Lead Local Flood Authority

RE: AL/11/24/OUT – Land East of Westergate, Westergate (part of BEW allocated site)

PL- Consultation- WSCC drainage response

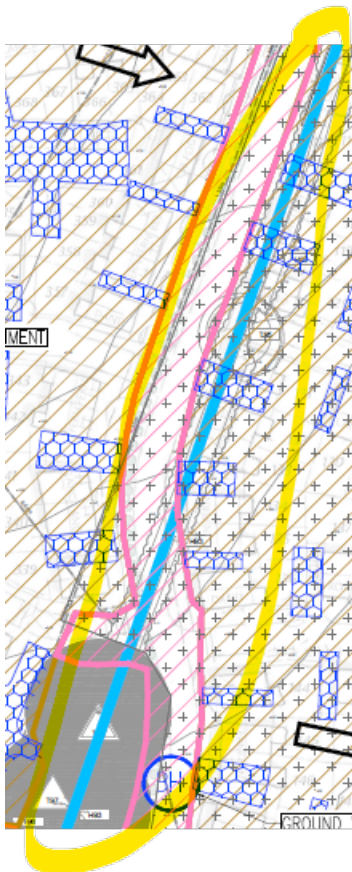
We have some concerns regarding the feasibility of providing the additional storage volume required for a design flood event (1 in 100 plus climate change event).
